**Addendum No. 2
January 20, 2023**

Project: Baltic High School Addition
Baltic, South Dakota
Arch Project No. 2957

Architect: Architecture Incorporated

FOUNDATION PLAN-AREA F
1/8" = 1'-0"

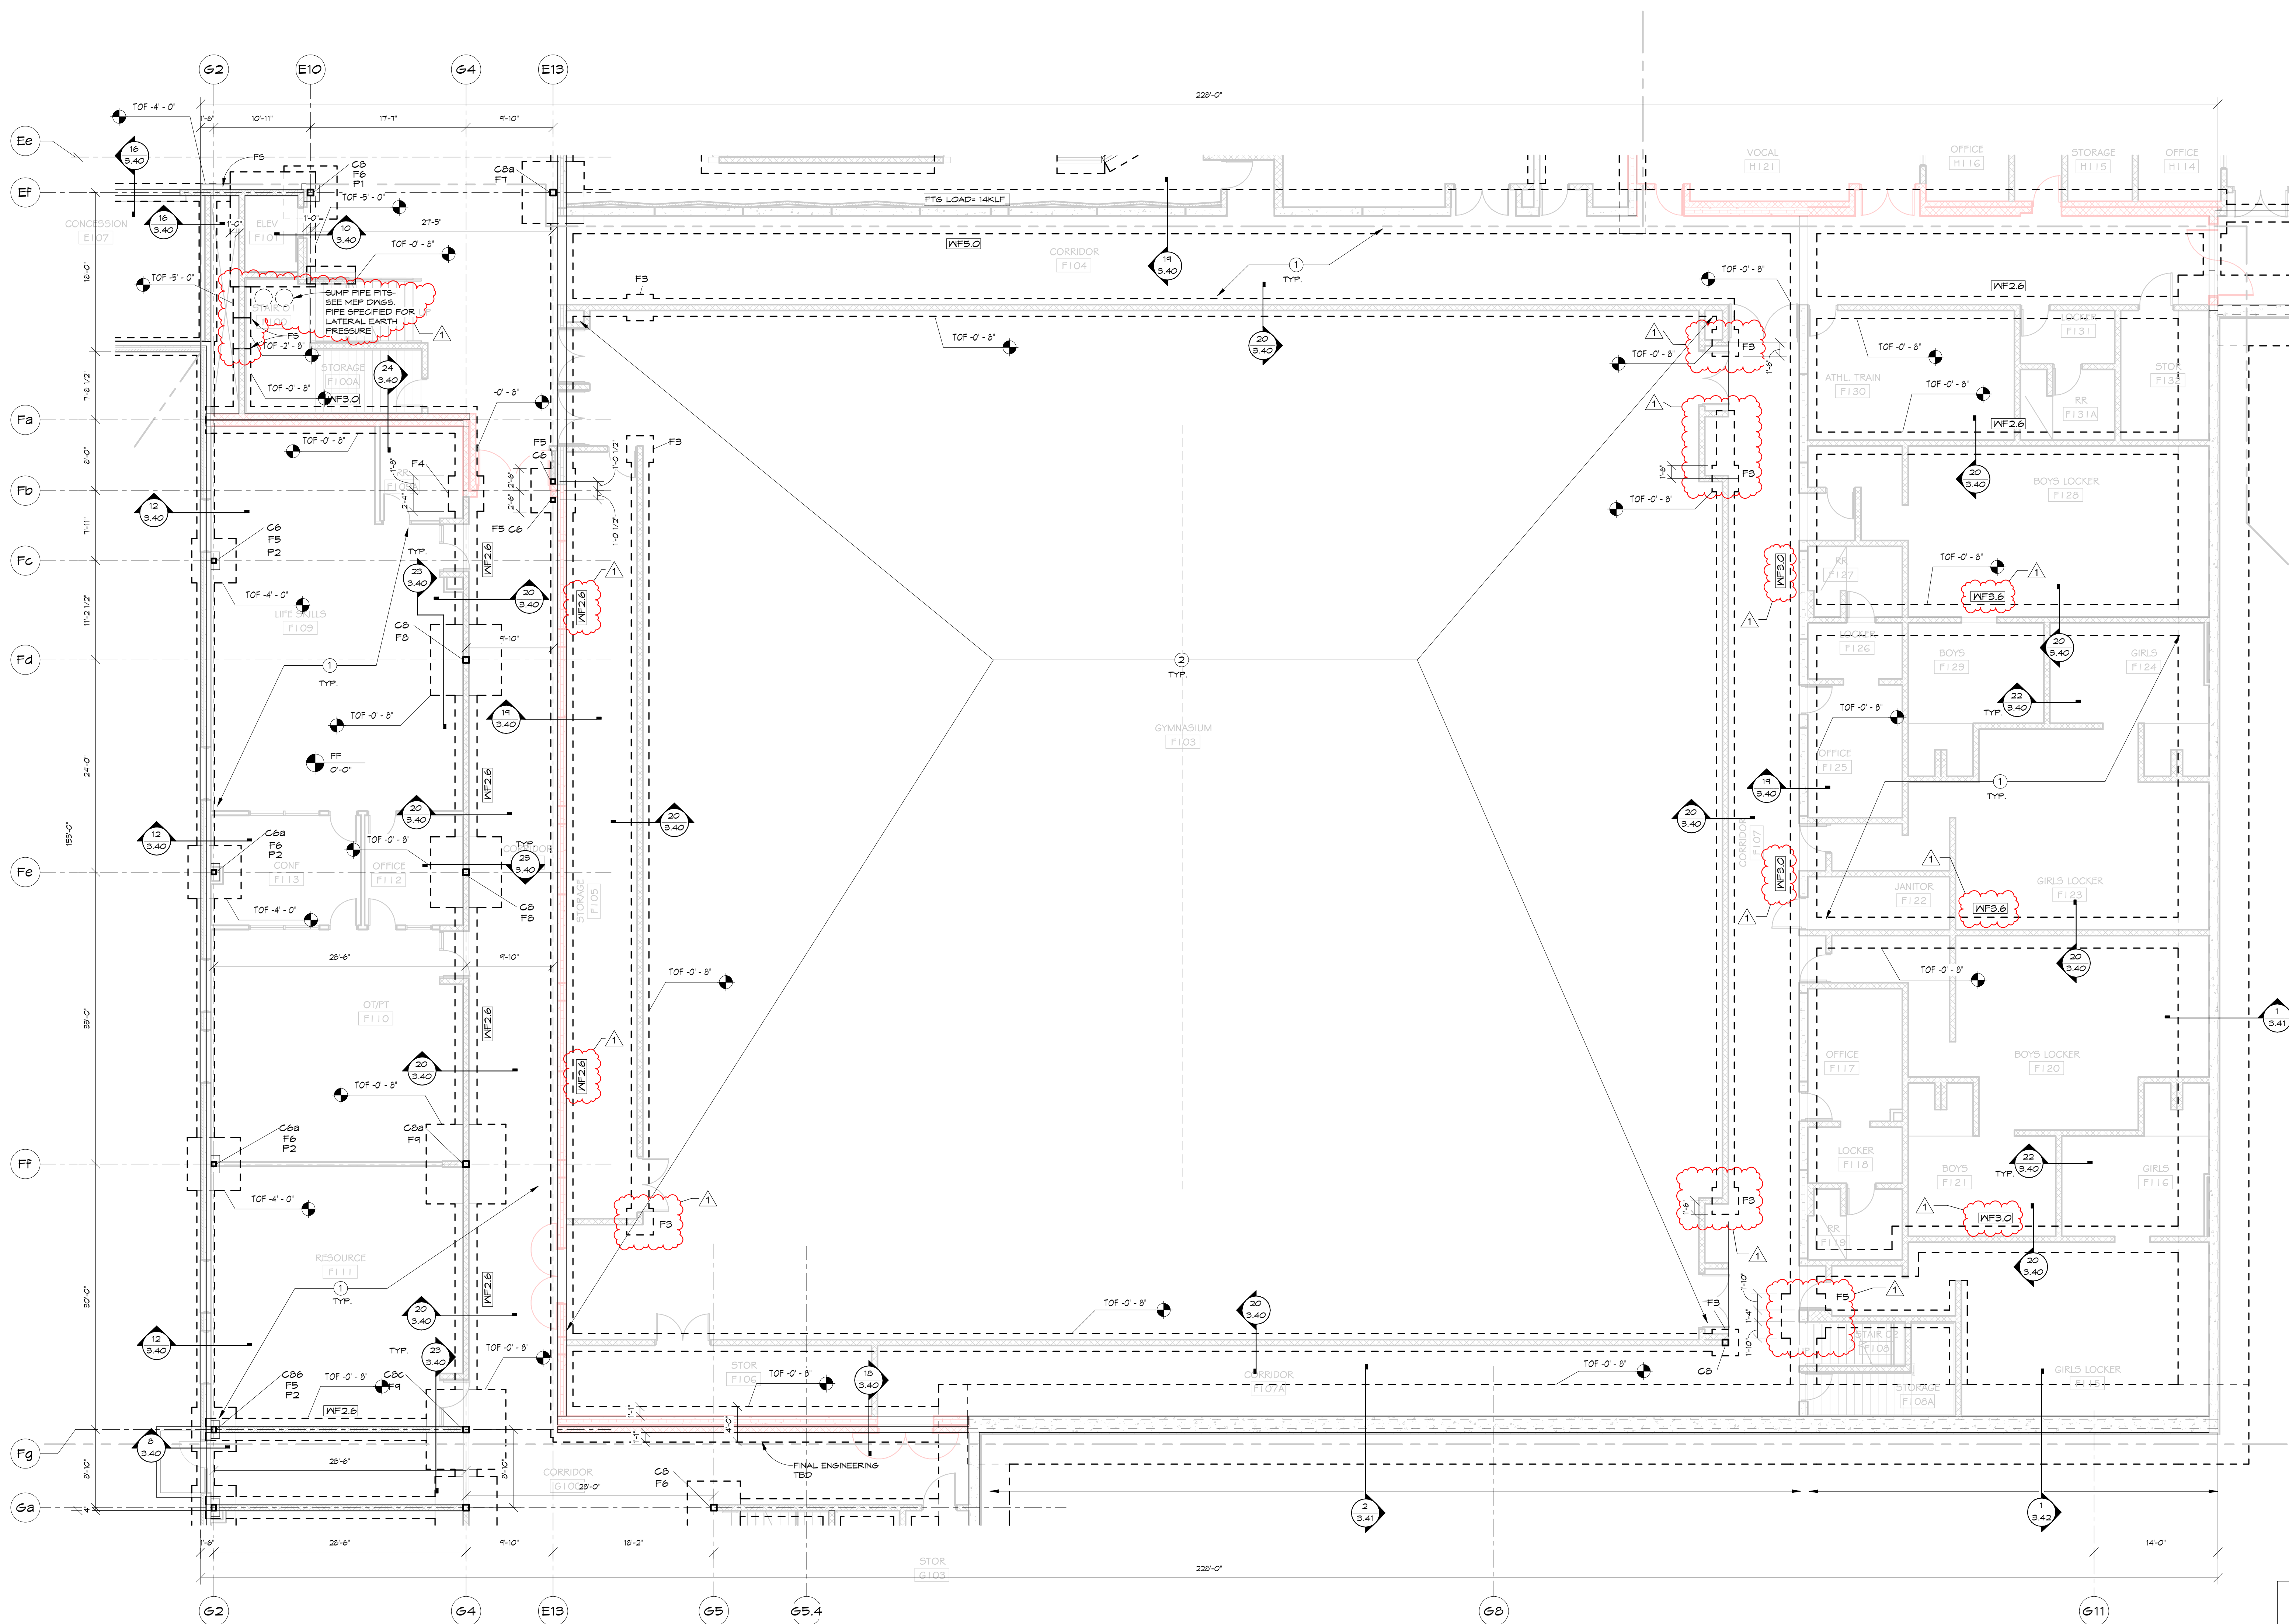
- a) Add footing step south of ELEV F101 as indicated per revised structural drawing Sheet 3.20-1F.
- b) Revise foundation locations and sizes around GYMNASIUM F103 walls per clouds on revised structural drawing Sheet 3.20-1F.
- c) Revise foundation sizes at BOYS and GIRLS LOCKER rooms per clouds on revised structural drawing Sheet 3.20-1F.
- d) Reference revised drawing Sheet 3.20-1F, revision dated 1-20-23, attached to the end of this addendum for structural changes listed above.

3.20-1G

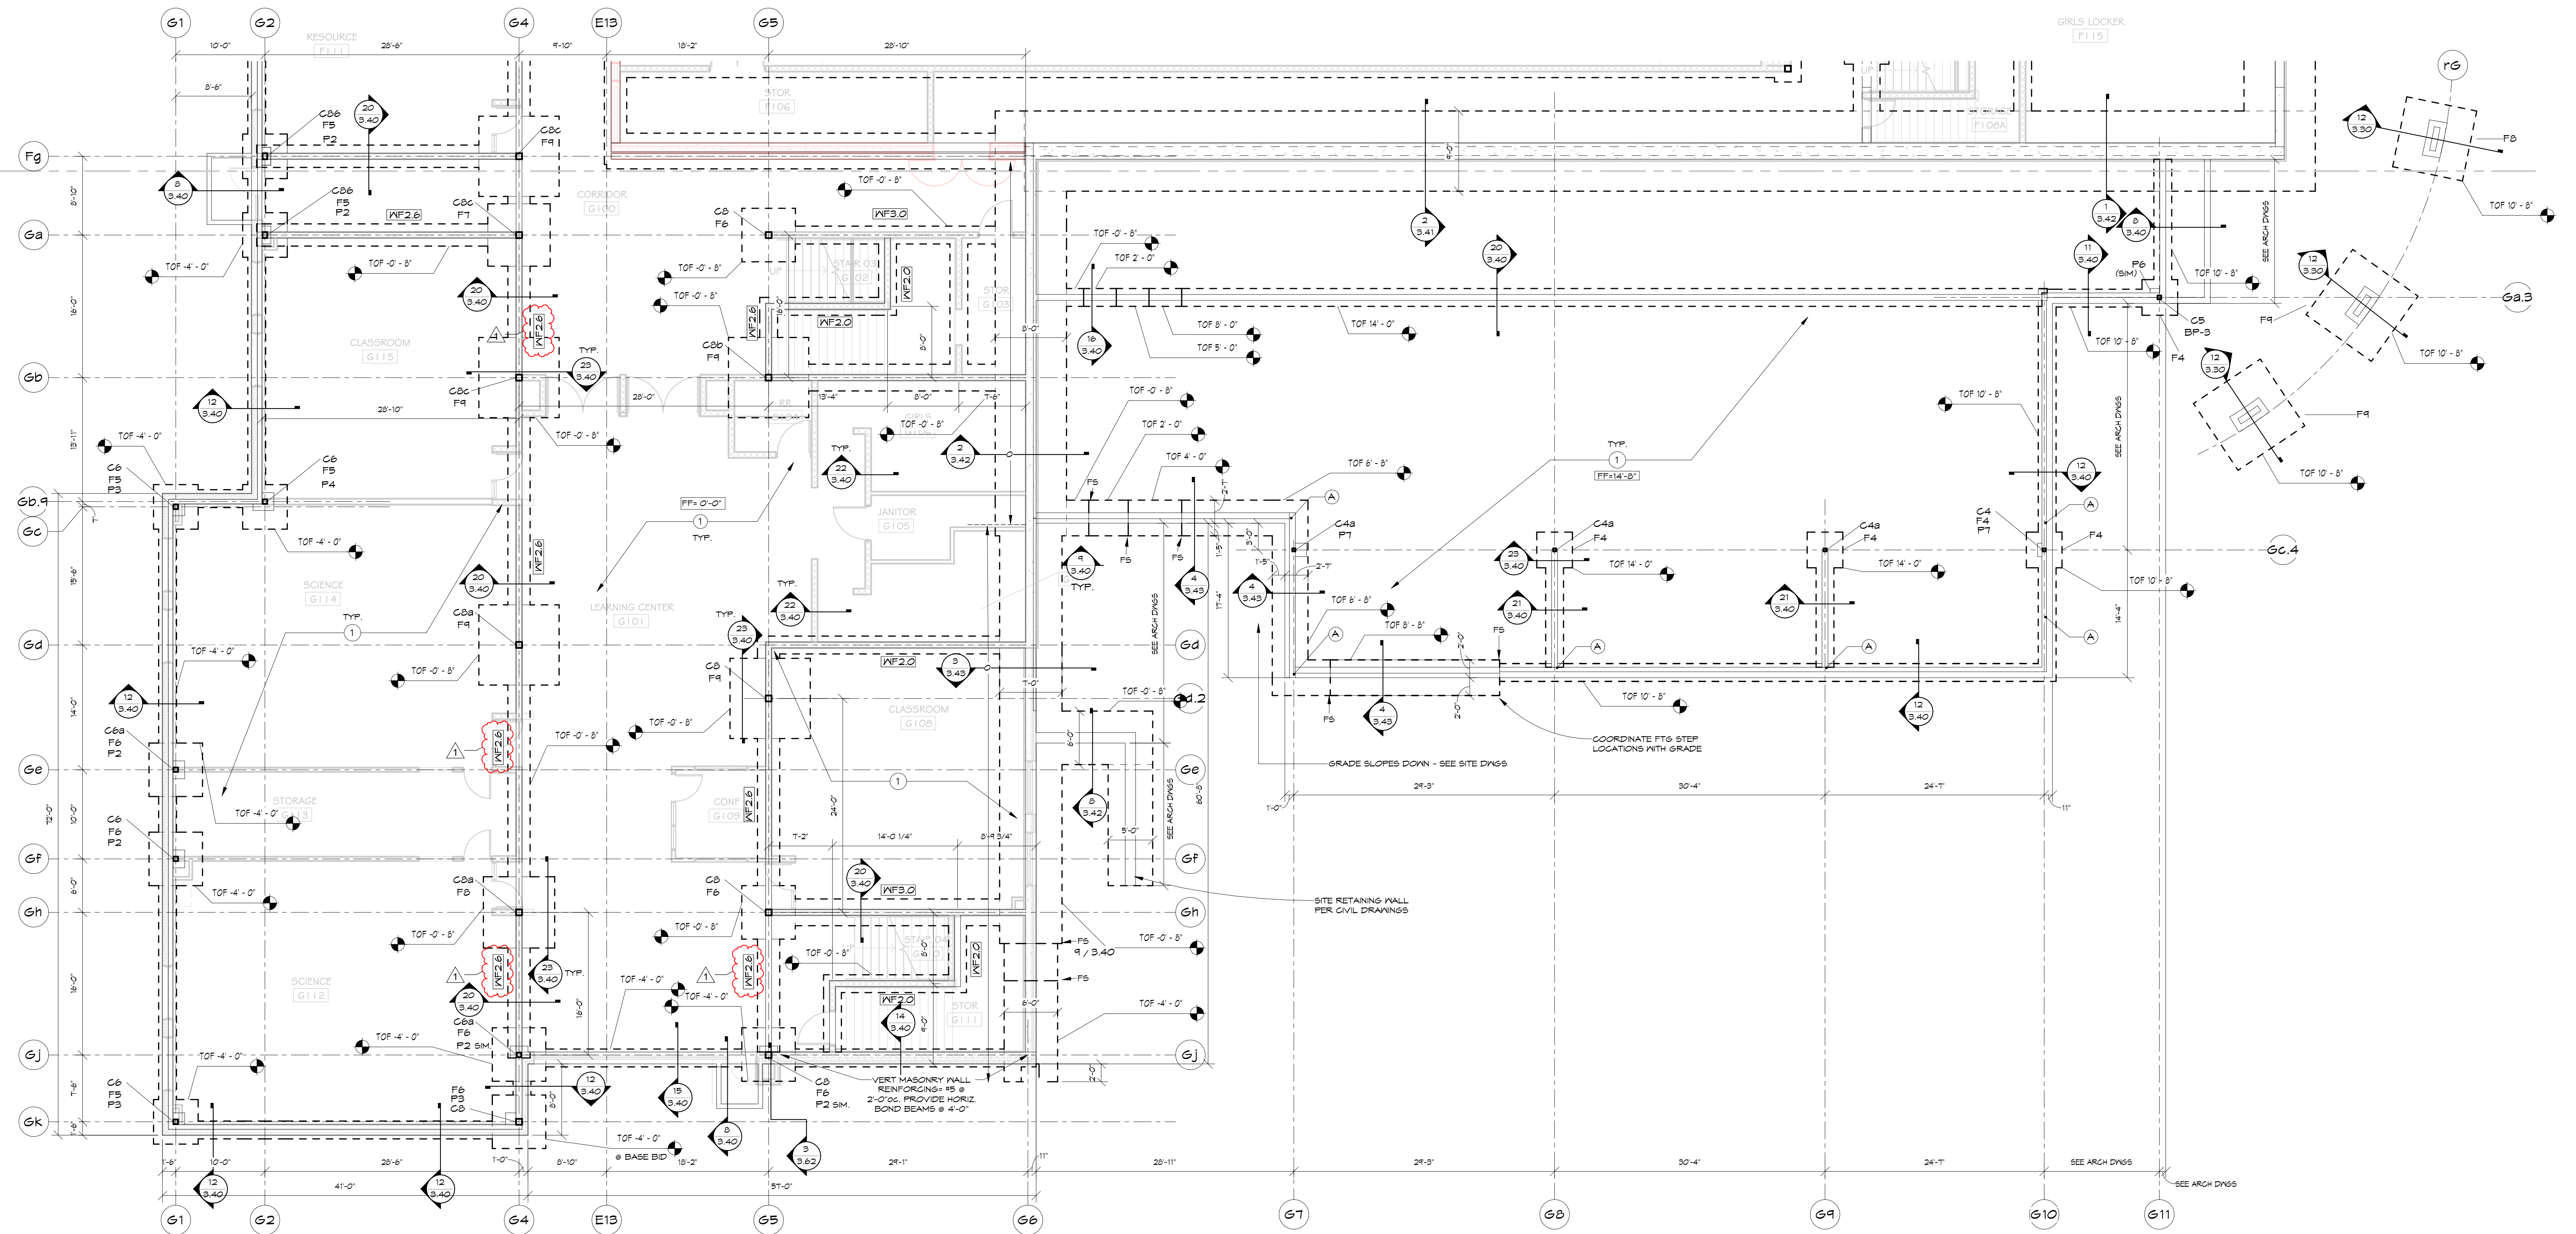
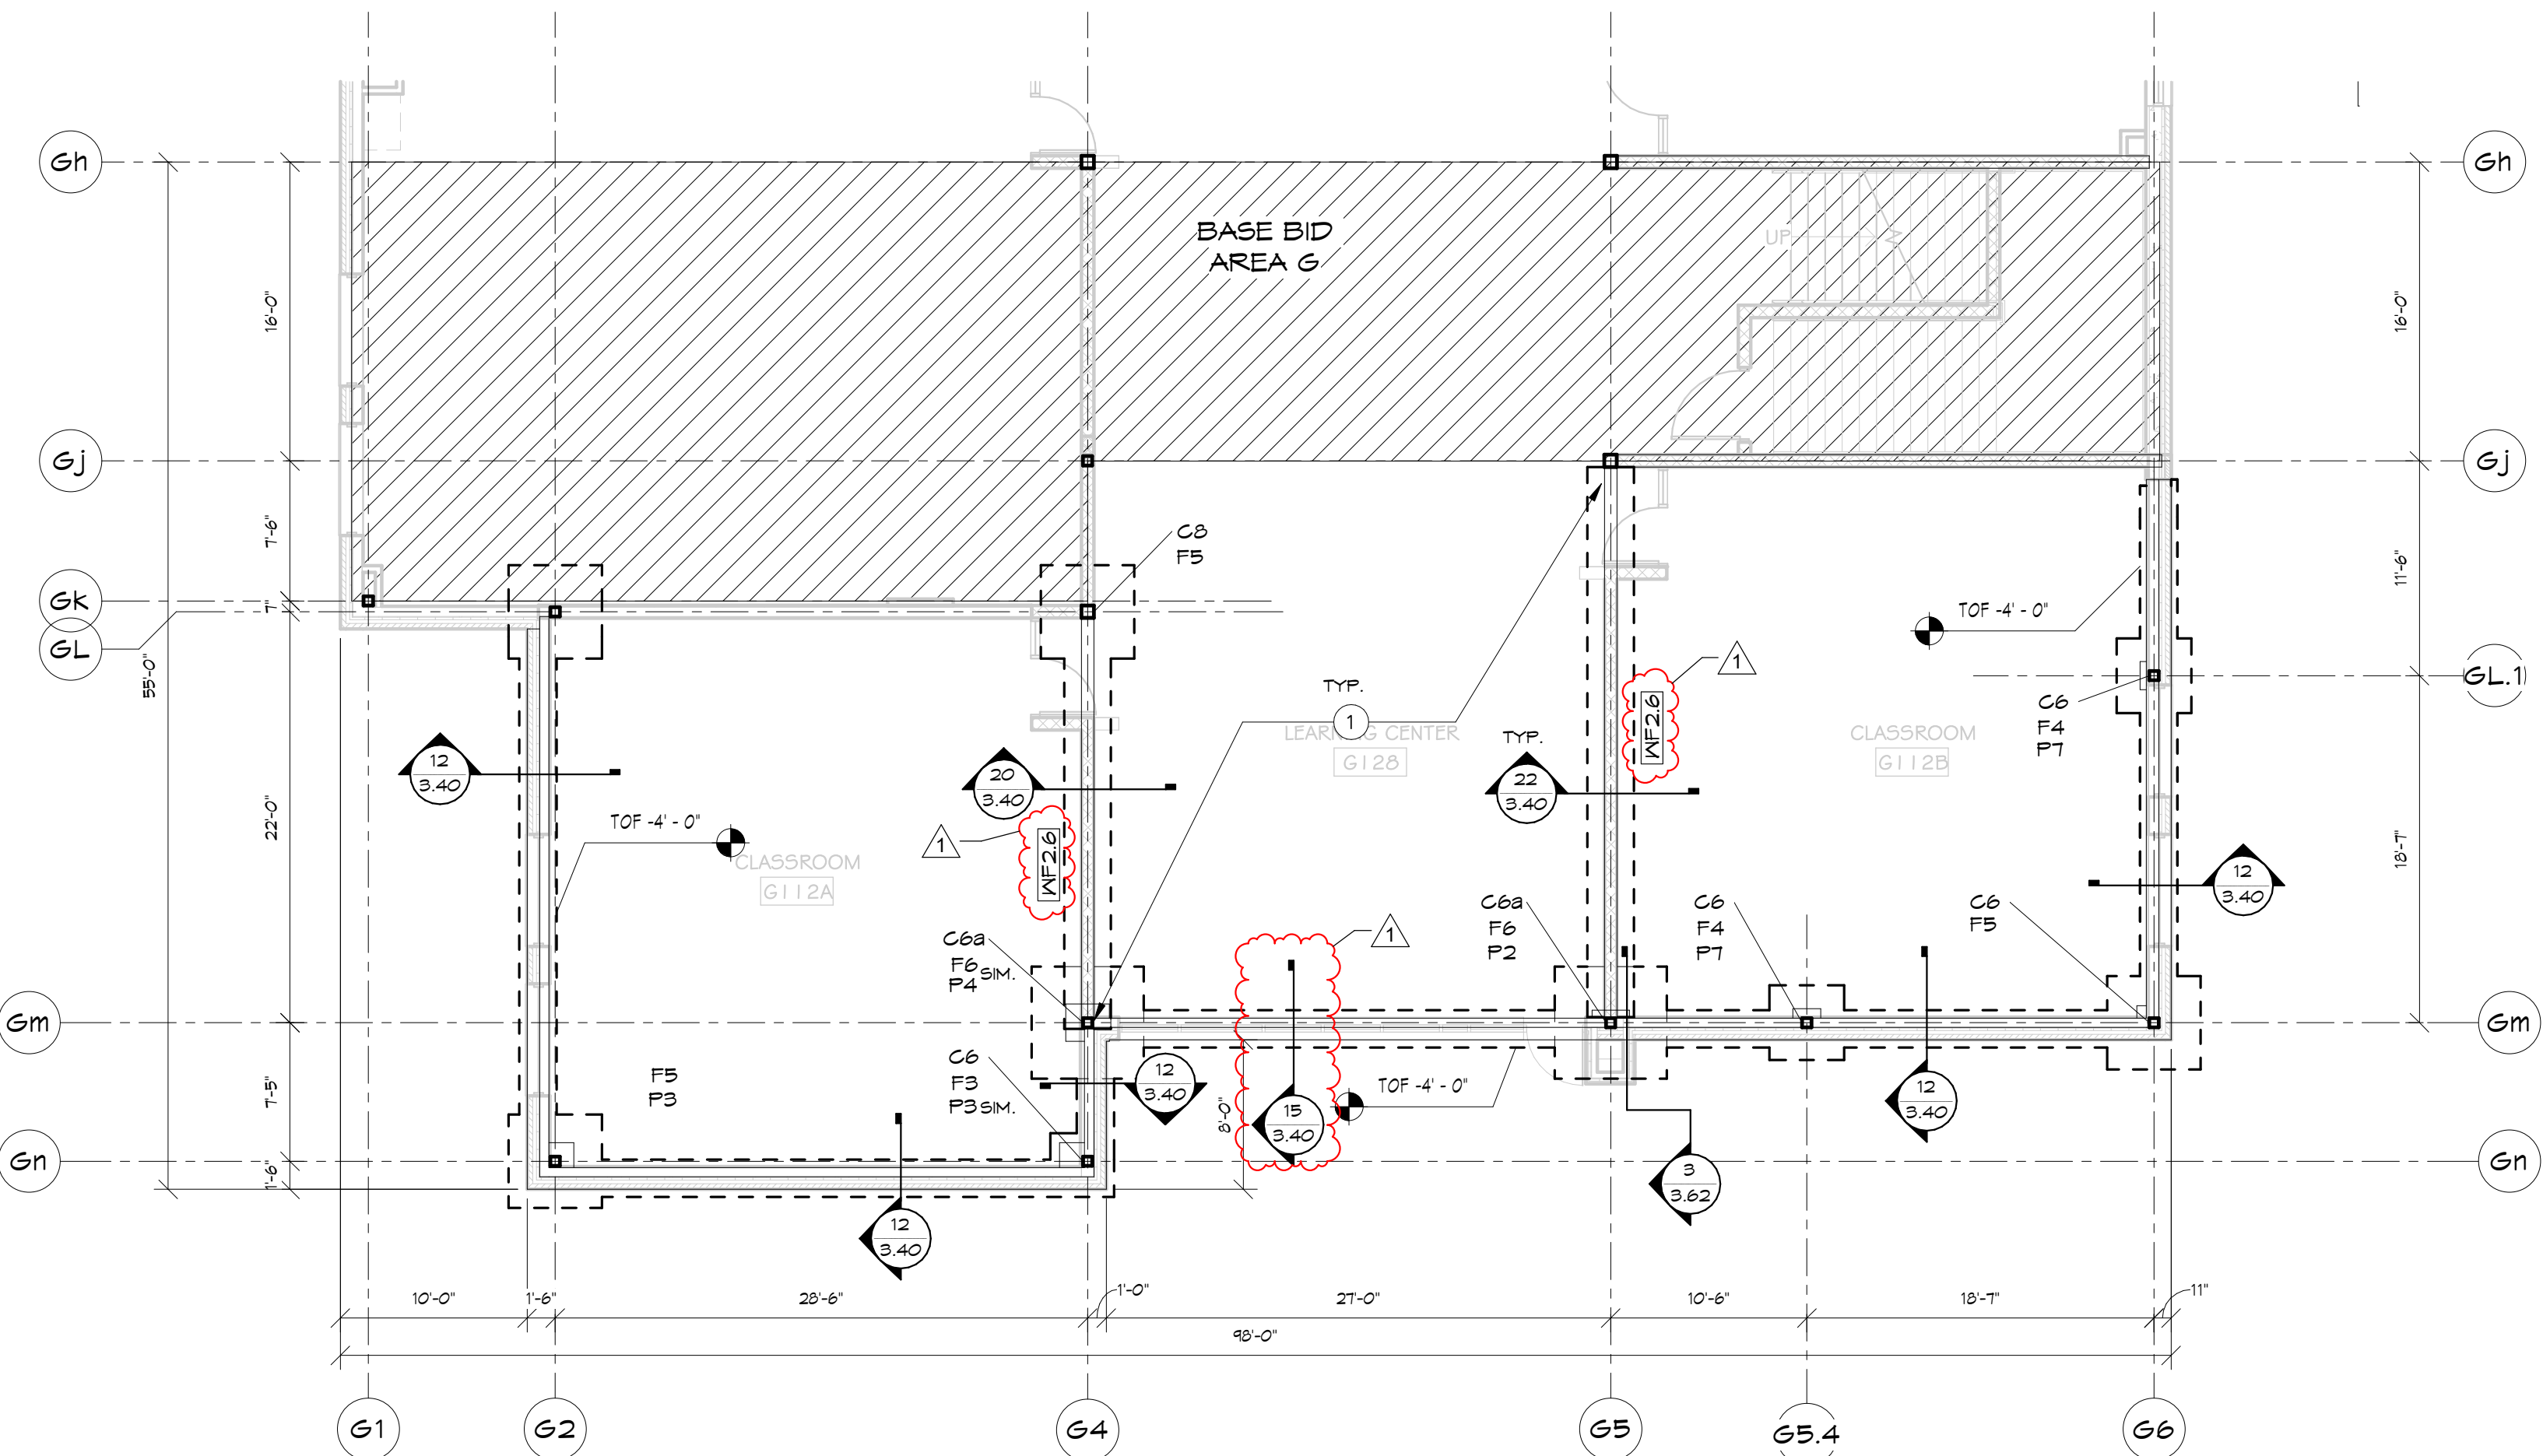
- a) Add detail cut reference 15/3.40 at south wall of LEARNING CENTER G128 (ref: ADD ALT area).
- b) Add “WF2.6” footing tags where shown at clouded locations on revised structural drawing Sheet 3.20-1G.
